Access Compliance Report

Public Rights-of-Way

(Curb Ramps)

Intersection ID: 12248	Main Street: E_8TH_ST	Cross Street: N_BREVARD_ST	Location:	N
ADA ID: 19CB3152129E	Ramp Type: Perp	Initial Pass/Fail: Pass	Overall Compliance: No	Severity Score: 10

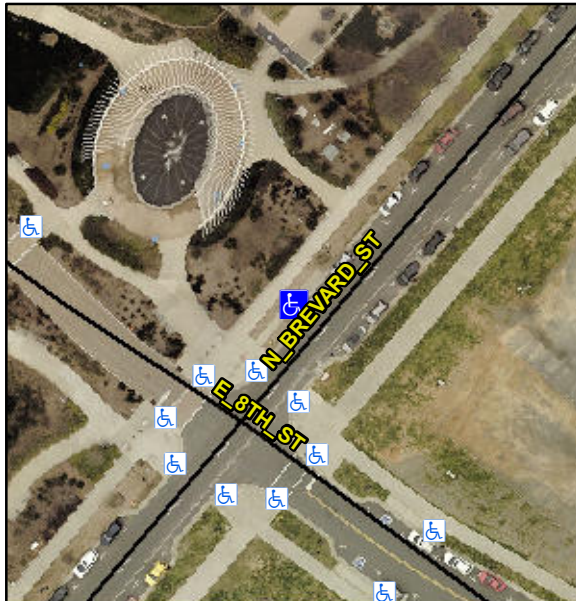
**R304.2.2-Perp, R304.3.2-Para, R305,
R302.7.2, R304.5.4, R304.5.3**

Compliance	Description	Data	Compliance	Description	Data
N/A	Ramp Length (in)	71.0	Yes	Ramp Slope (%)	7.1
Yes	Ramp Width (in)	48.0	Yes	Ramp XSlope (%)	1.3
Yes	Flare Type L	Curbed_NoWalkSurface	Yes	Flare Type RT	N/A
Yes	Flare Slope LT (%)	N/A	N/A	Flare Slope RT (%)	N/A
N/A	Flare Traversable LT?	No	N/A	Flare Traversable RT?	No
Yes	Landing Length (in)	64.0	No	DWS Provided?	No
Yes	Landing Width (in)	59.0	N/A	DWS Contrast?	No
No	Landing Slope (%)	2.7	N/A	DWS Length (in)	N/A
Yes	Landing X Slope (%)	0.9	N/A	DWS Full Width?	No
N/A	Landing Curb? (Y/N)	No	N/A	DWS Offset (in)	N/A
N/A	Shared Landing?	No			
Yes	Gutter Ponding?	No	No	Gutter Slope (%)	N/A
No	Gutter Lip Ht (in)	N/A	No	Gutter X Slope (%)	N/A
N/A	Painted X Walk1?	No	N/A	Painted X Walk2?	N/A
	X Walk 1 Direction	To S		X Walk 2 Direction	N/A
N/A	X Walk 1 Width (in)	N/A	N/A	X Walk 2 Width (in)	N/A
	X Walk 1 Slope (%)	0.1		X Walk 2 Slope (%)	N/A
	X Walk 1 X Slope (%)	1.3		X Walk 2 X Slope (%)	N/A

**Remove & Replace Entire Ramp.
Remove & Replace Gutter.**
